ADDENDUM NO. 03 ISSUED: 9.02.2026

**to the Project Manual and Drawings for
UAPB Pedestrian Mall - Phase 1 (TAP-16)(S)
ARDOT PROJECT # 020673**

UAPB Pedestrian Mall - Phase 1 (TAP-16)(S)

ARDOT PROJECT # 020673

EZ Roll™
Grass Pavers

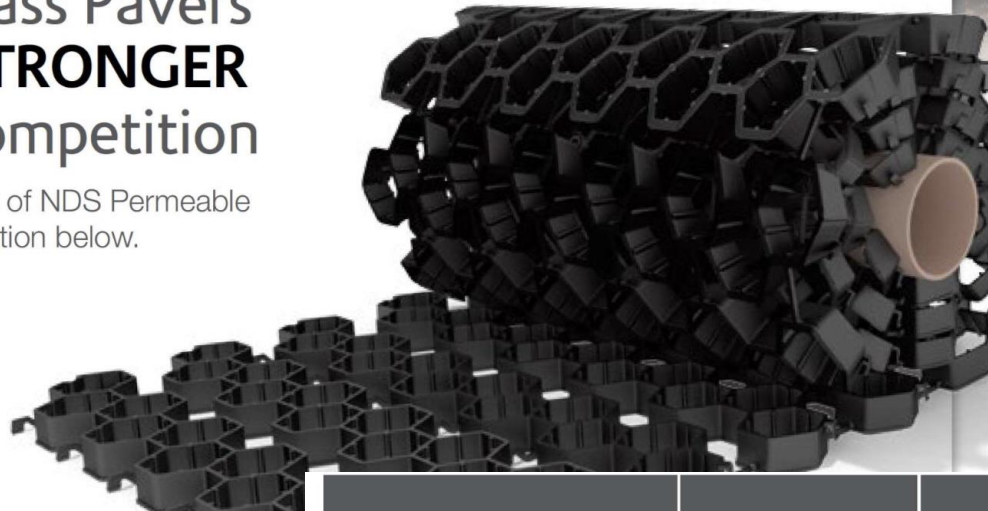
1. **EZ Roll™ Grass Pavers**, manufactured by **NDS®**, in lieu of **TruGrid**.

Response: This is an acceptable substitution. Product data attached.

C-001

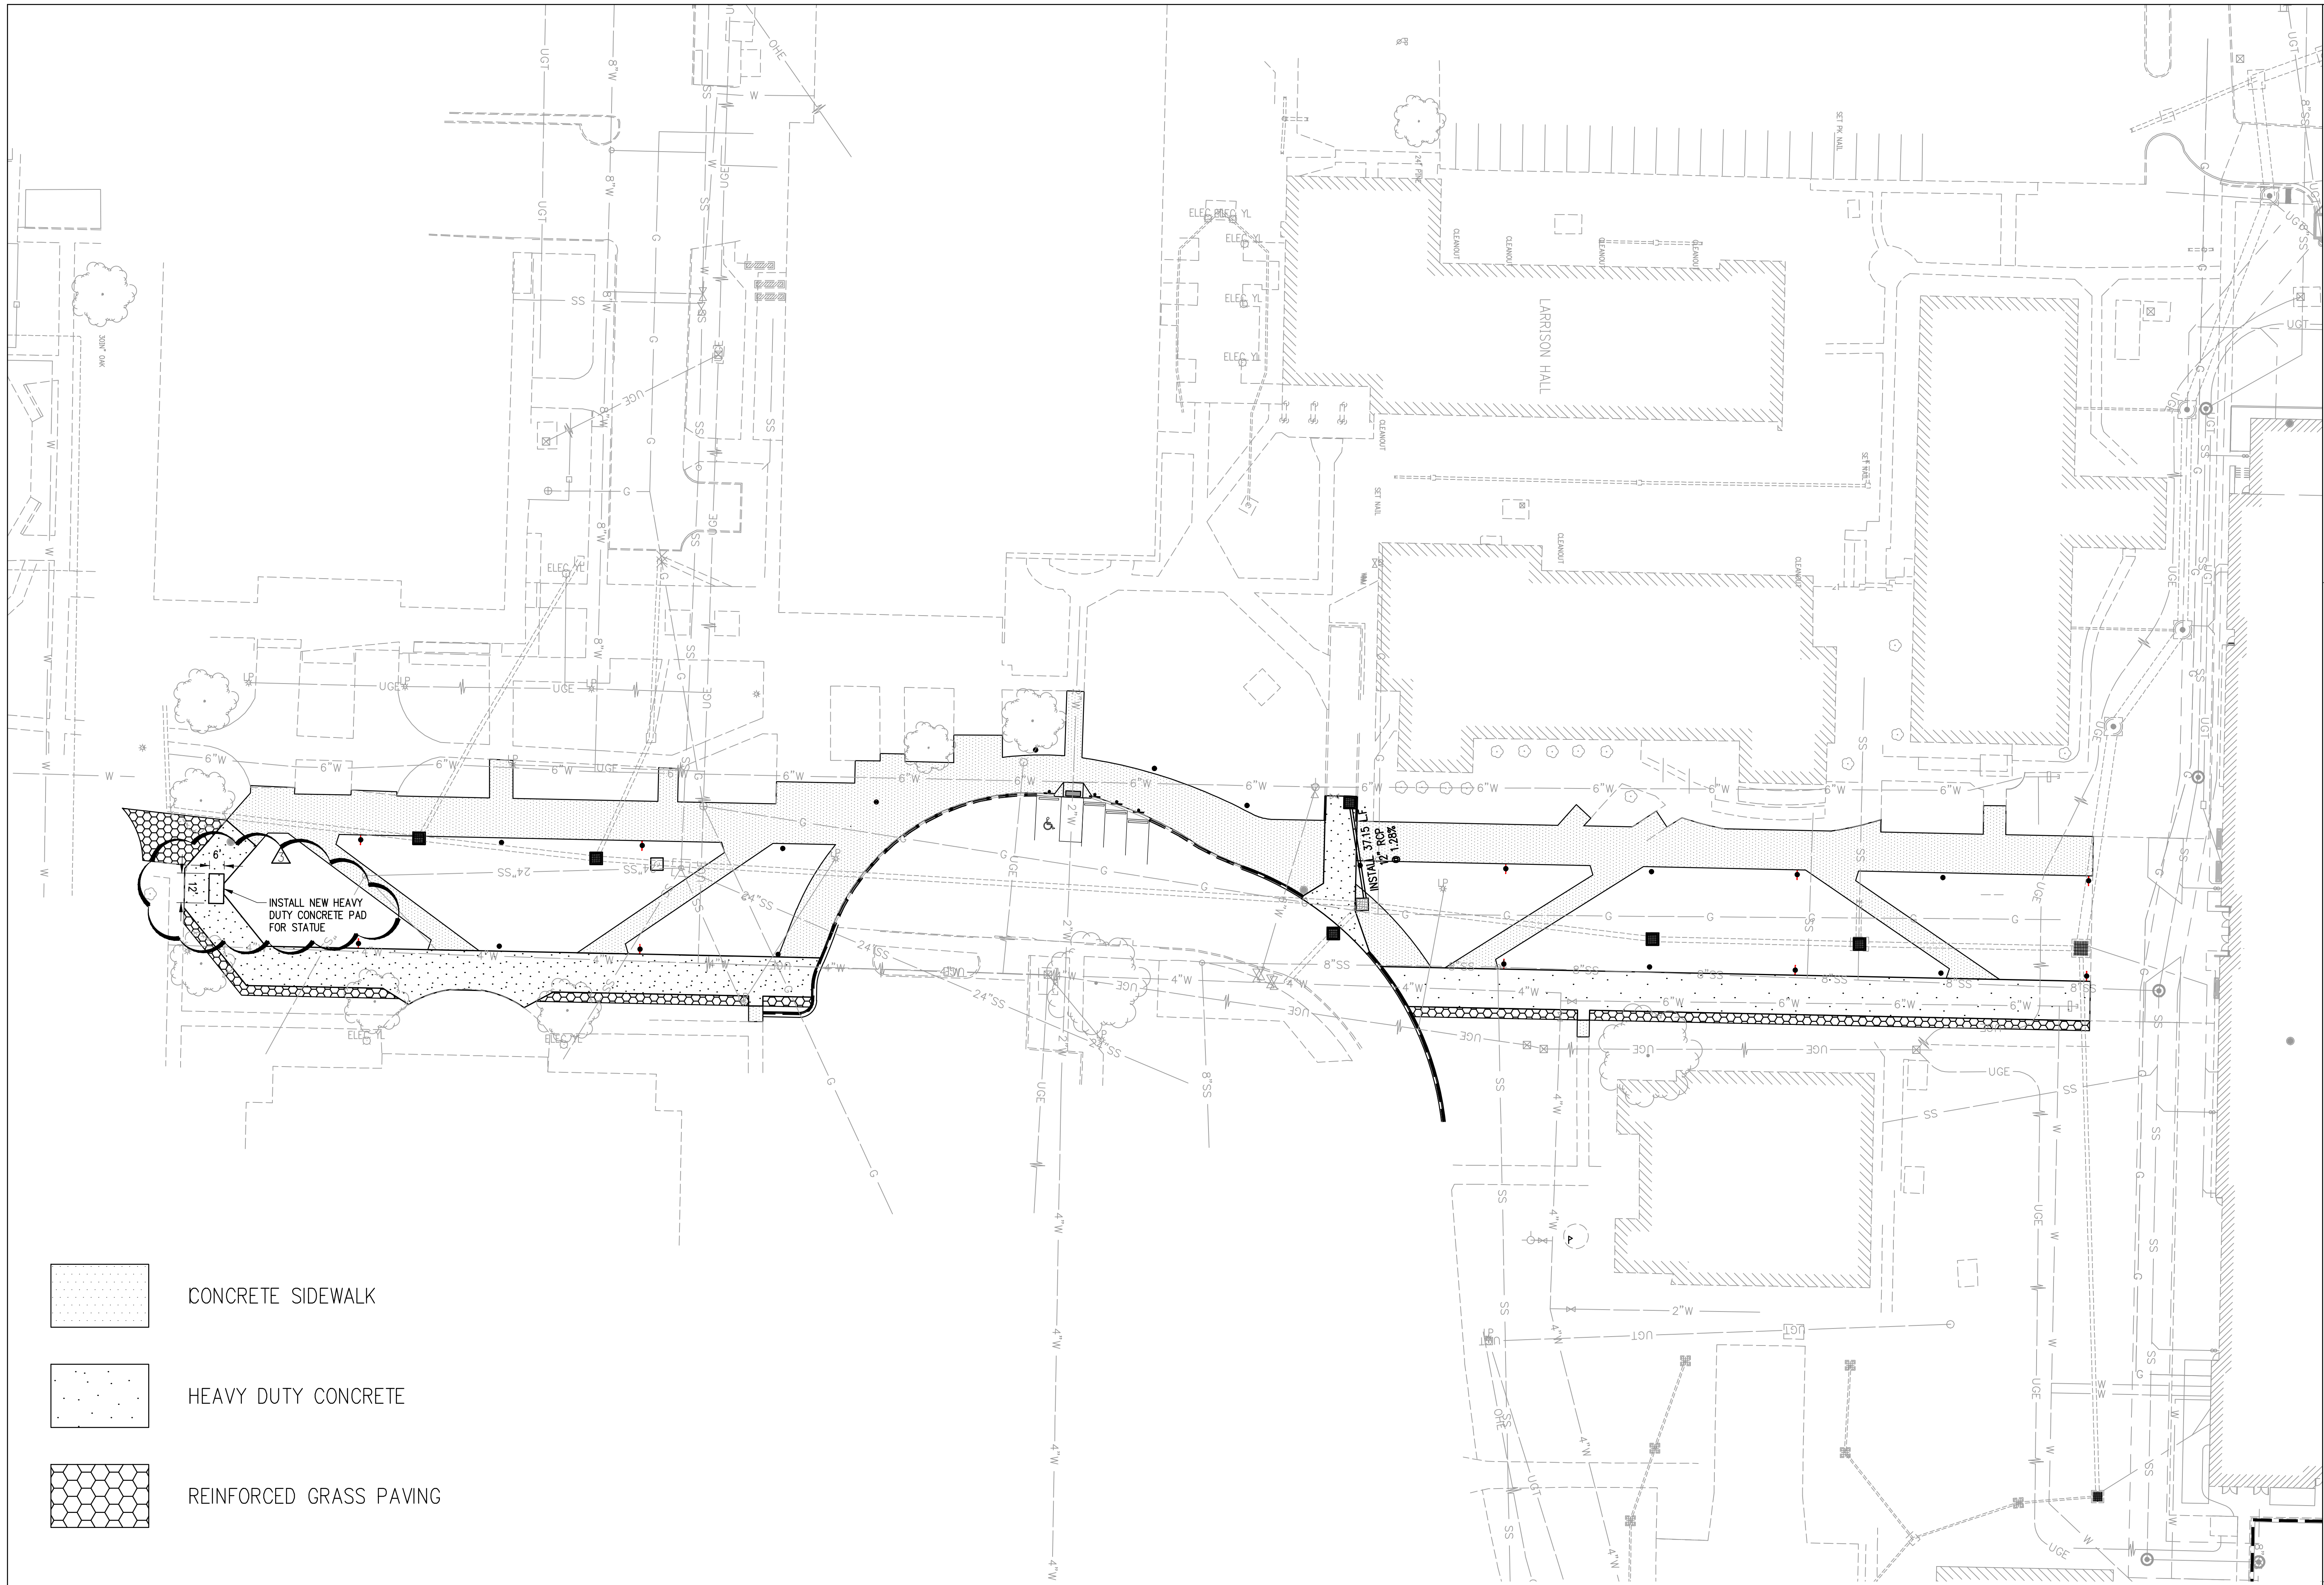
1. Refer to attached revised drawing SHEET C-001 for revised quantities.
2. Refer to attached revised drawing SHEETS C-103 for location of statue.
3. Refer to attached revised drawing SHEETS C-109 for acreage summary.
4. Refer to attached revised drawing SHEETS C-110 for corrected sheet name.
5. Refer to attached revised drawing SHEETS C-502 for updated concrete pavement jointing detail.

Ref: Sheet C-001 quantity table shows Item 714 Light Pole Foundation, 23 EA; Detail 2/E101. Addendum No. 1 revised Sheet C-001 and added Item 906 Removable Bollard to the quantity table, but did not add Light Pole Foundation to Bid Schedule 00 41 00. Revised C-001 now lists 34 pay items; the Bid Schedule lists 33

Ref: Addendum No. 1 revised Sheets C-107 and C-108 for revised limits of disturbance and erosion controls, but Item 331 Silt Fence remains 1,135 LF and Item 321 Grate Inlet Gravel Filter remains 10 EA on revised Sheet C-001. Sheet C-109 was not revised and still shows 1.43 acres disturbed, 0.65 acre impervious and 0.78 acre seeded

Response: "714 - LIGHT POLE FOUNDATION" Line item added to bid schedule

Response: Silt fence quantities and area of disturbance will be corrected. Inlet filter quantities are correct. There is no site specific NPDES permit for this project. Automatic SWPPP coverage for 1-3 acres of disturbance applies to the site.

C-110

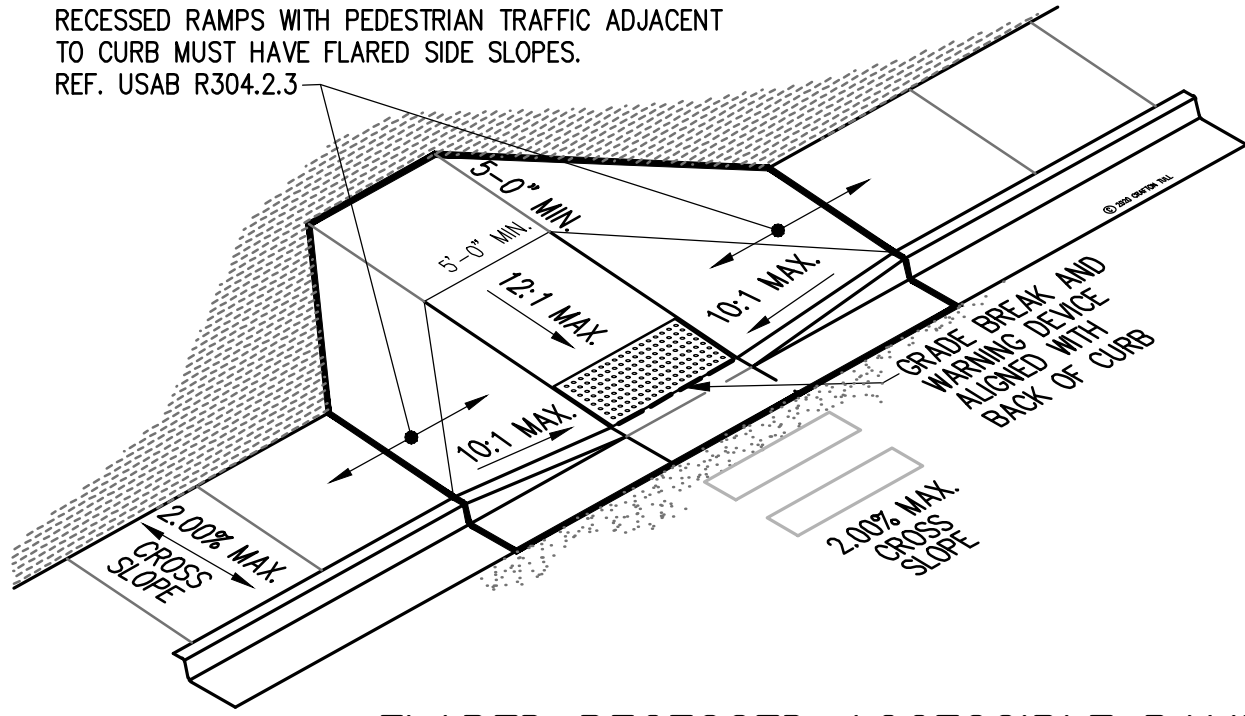
Ref: Sheets C-110 (revised by Addendum No. 1) and C-111 both use only "CJ — contraction joint" and "EJ — expansion joint." Neither references the Type A, B, C, D, S and SH joints detailed on Sheet C-502, which was not revised. The revised C-110 drawing title reads "Sht. 2" while its title block reads "Jointing Plan Sht. 1"

Question: Which joint type from Sheet C-502 applies to each CJ and each EJ designation, and will the C-110 sheet title be corrected?

Response: Expansion joints are to be Type A, contraction joints to be Type S.

DETECTABLE WARNING DEVICE
NTS AUG. 25, 2020

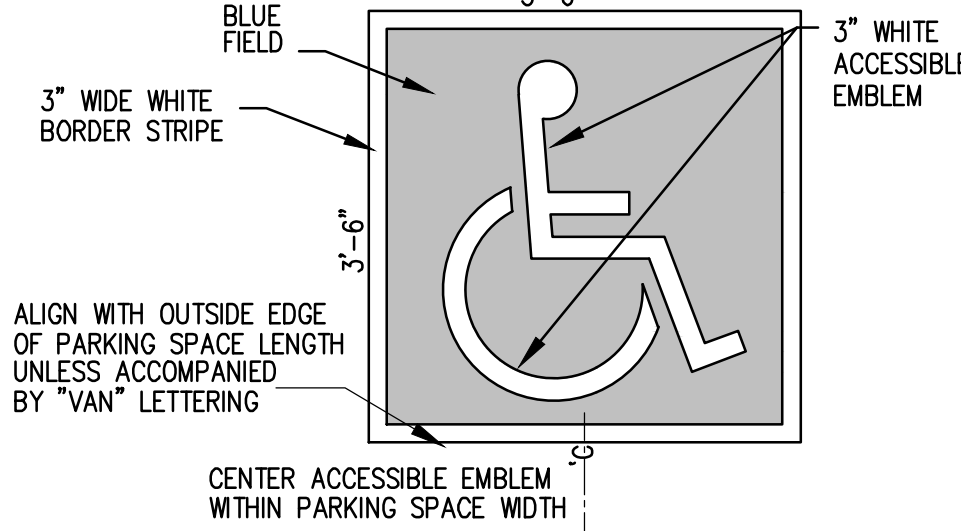
Ref: Sheet C-502 allows any material and either contrast; ARDOT Subsection 641.02 requires cast-in-place vitrified polymer composite in Federal Color No. 33538 and prohibits surface-applied products

Question: Does ARDOT Subsection 641.02 govern the detectable warning devices, and does the ramp follow Standard Drawing WR-1?

Response: Yes.

CONCRETE PAVEMENT JOINTING DETAIL
NTS AUG. 25, 2020

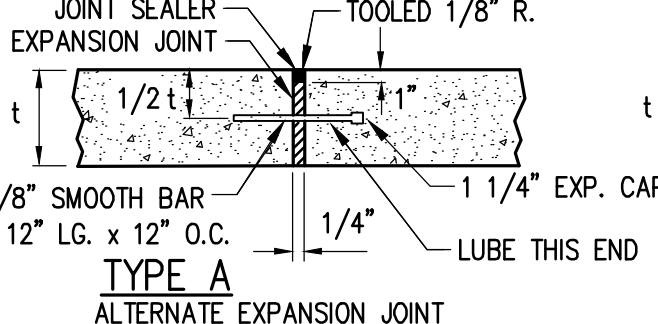
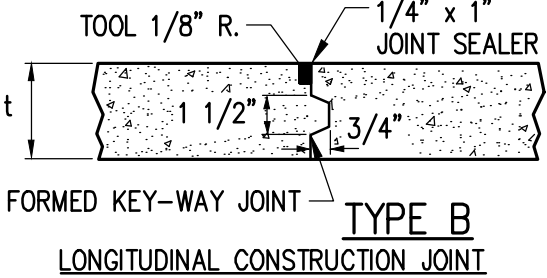
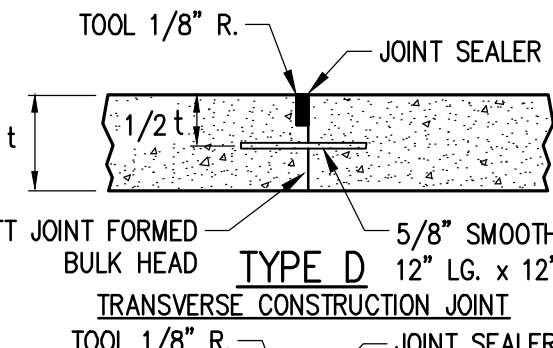
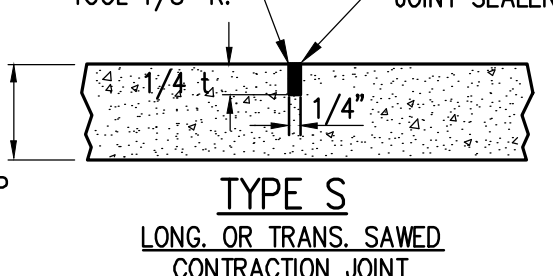
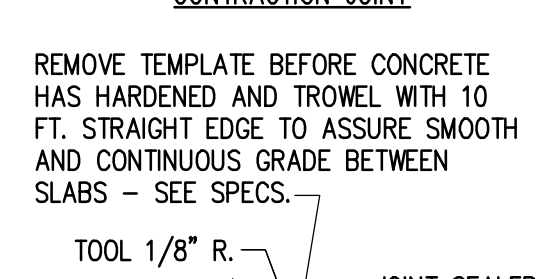
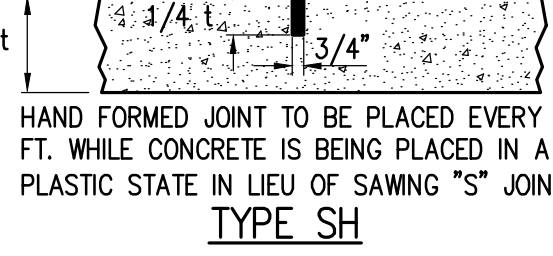
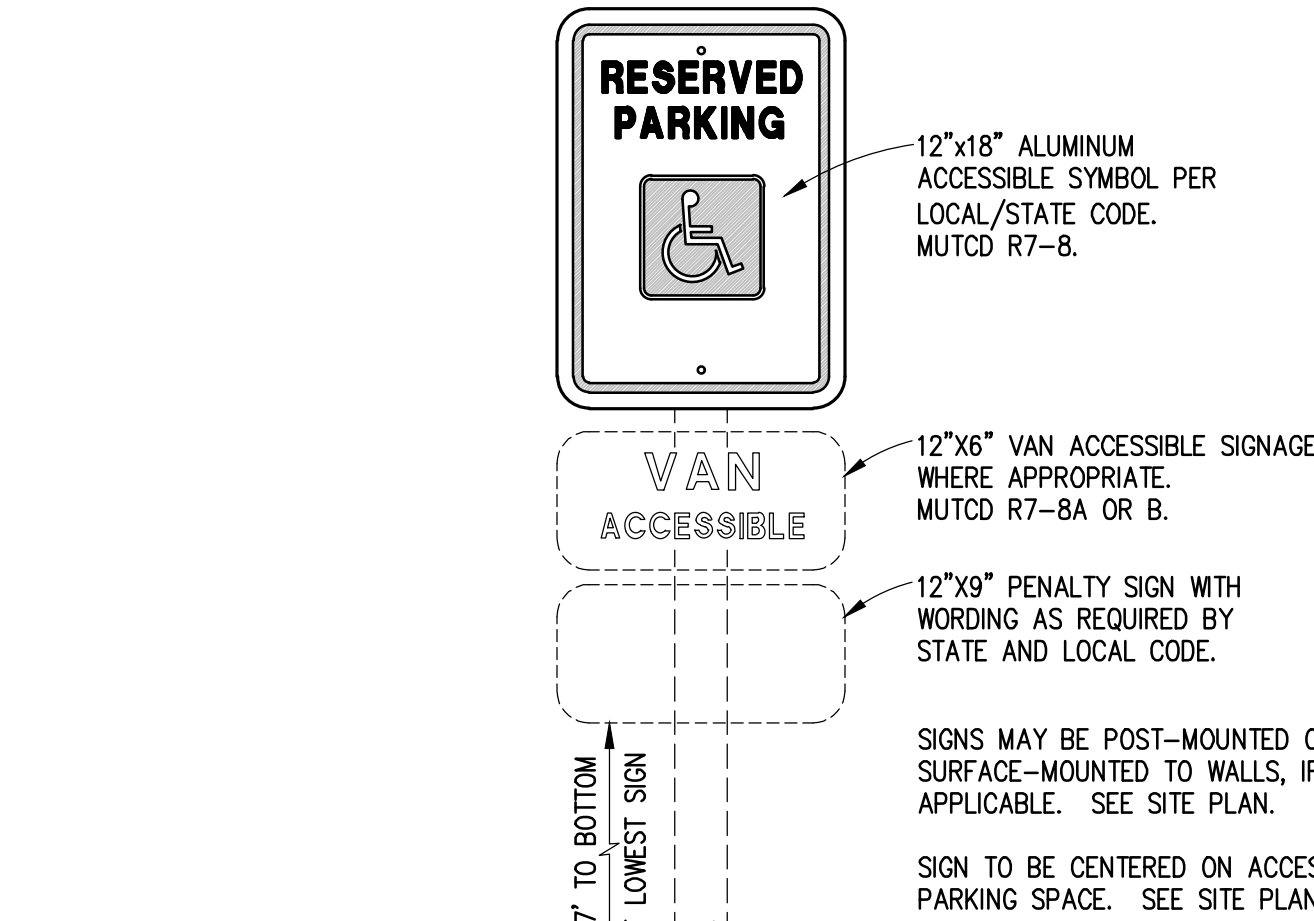
Ref: Sheet C-502, Concrete Pavement Jointing Detail, Note 4 requires "specified joint sealant" applied per the manufacturer's requirements and tooled 1/8 in. below the pavement surface; no joint sealant specification appears in the Project Manual

Question: Please provide the exterior joint sealant specification, including product type and acceptable manufacturers, that we are to price.

Response: Exterior joint sealant shall be single component self leveling sealant, Sikaflex + Self Leveling Sealant or equal.
